## Notification of changes

### SAW filters: Relocation within Wuxi, China, and redesign of the laser markings

120629SAW2e

**Product / Process Change Notification  
Produkt-/ Prozess-Änderungsmitteilung**

#### Package < 5 x 5 mm (sizes 2520, 3025, 3030, 3838, 5050)

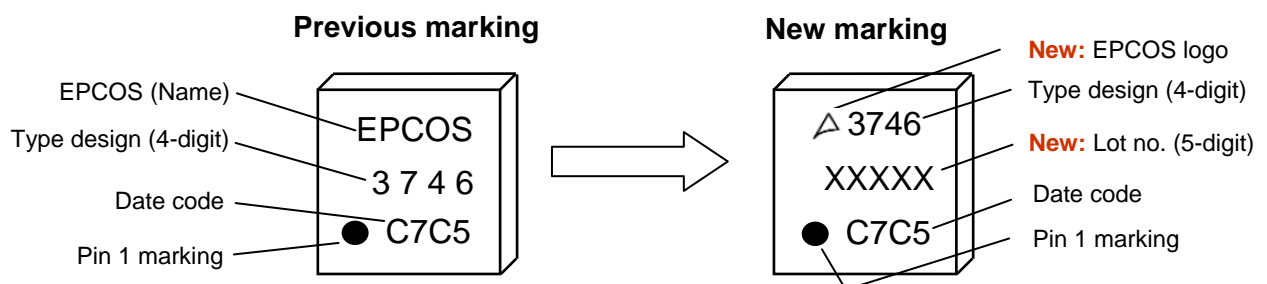
Simultaneously with the transfer, the laser markings on the packages of all affected SAW filters will be changed as shown below:

- Fast unequivocal identification of goods from new production. The laser markings will be changed simultaneously with the start of production in the new plant.
- The additional lot number (last five digits) enables faster traceability in production.
